BLUE BIRD

R10RW

SUBJECT: RECALL R10RW POWER CABLE LUG ORIENTATION

Incorrect Power Cable Lug Orientation

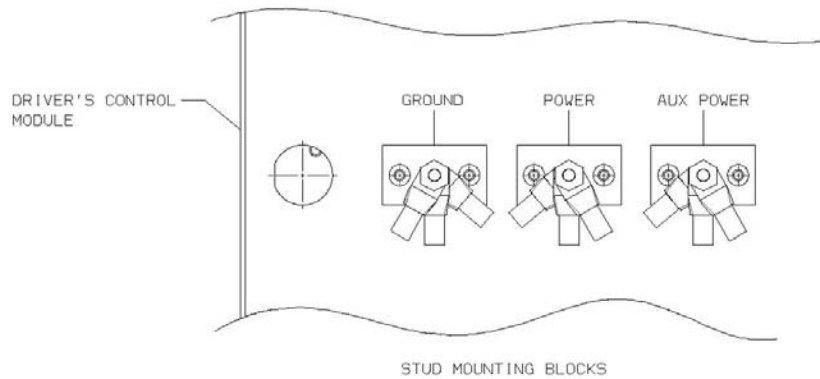
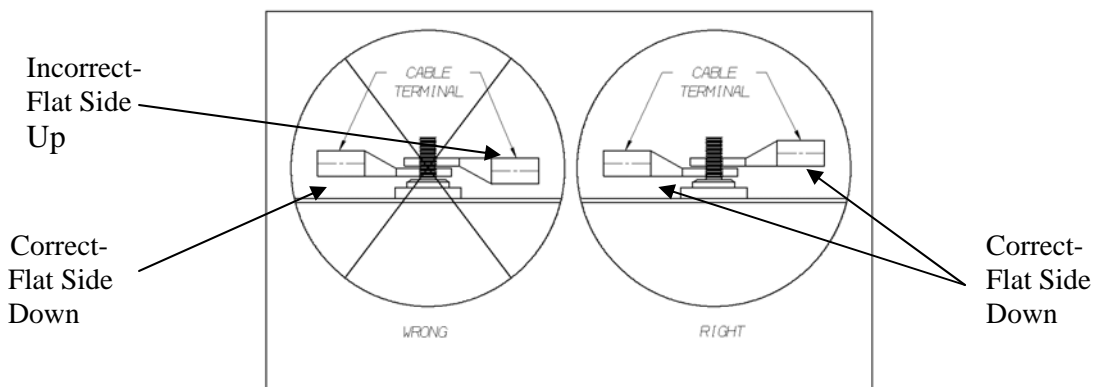
1. Park the vehicle on a level surface, apply parking brake, turn engine off, remove ignition key and chock wheels.
2. Disconnect batteries. *Always remove negative cables first.*
3. Open engine hood and locate the Chassis Power Stud(s) on the driver's side of the **Driver's Control Module (DCM)**. Depending on the type of engine installed and options on the vehicle (air conditioning and/or lift), there could be one or two power studs next to the Ground Stud. See the following diagrams.

4. Inspect the electrical cable connections at the Power Stud and Aux Power Stud, if installed. See the diagram below to determine if the cables were installed correctly. ALL terminal lugs on each power stud should be oriented such that the barrel of the lug is further away from the mounting surface of the isolated stud. The flat side of terminal end (lug) must be down.

5. If the cables were installed incorrectly, remove the nut securing the cables. Then remove the cables and reinstall correctly per the diagram above. Make sure the terminal lugs are fanned out on the stud as opposed to directly on top of each other. Vice-grip pliers are recommended when turning incorrectly installed cable terminal lug to the correct orientation of flat side down.

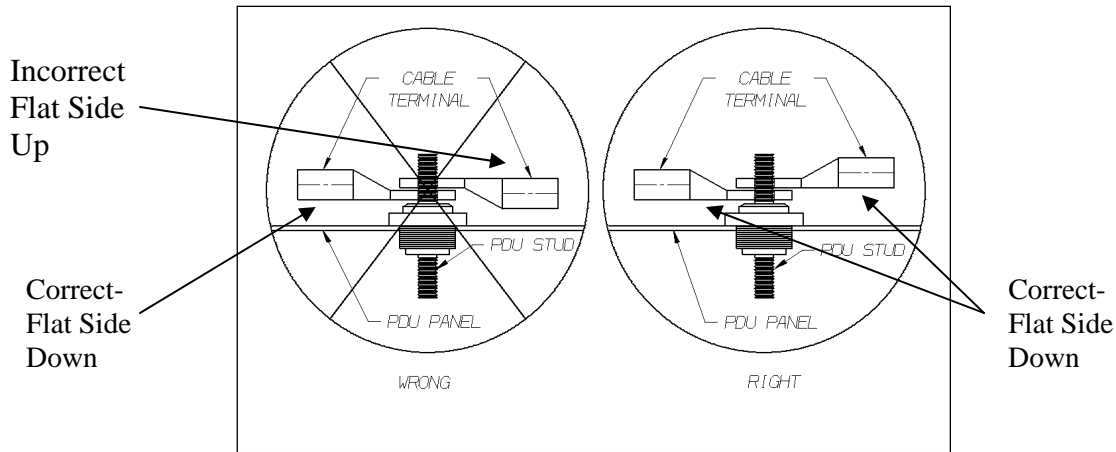
9. Next, locate and inspect the two Power Studs below the 4 Deutsch connectors.

10. Remove the two red protective covers and inspect the electrical cable connections at the Power Studs.

ALL terminal lugs on each power stud should be oriented such that the barrel of the lug is further away from the mounting surface of the isolated stud. The flat side must be down.

11. Remove the nut securing the cables. Then remove the incorrectly installed cables and reinstall correctly with flat side down. Make sure the terminal lugs are fanned out on the stud as oppose to directly on top of each other.
12. If needed, use vise grips to rotate cable so lug fits with flat side down. See photo on page 2.
13. Secure the cables with the nut and torque to 12 to 15 ft-lbs.
14. Apply corrosion resistant coating (glyptal) as required to prevent corrosion.
15. Reinstall the red protective covers.
16. While having access to this area, inspect ALL power cables for any evidence of contact with the rear of the engine, chaffing, or other damage. **Ensure clearance between power cables and any part of the engine is more than ½ inch.**
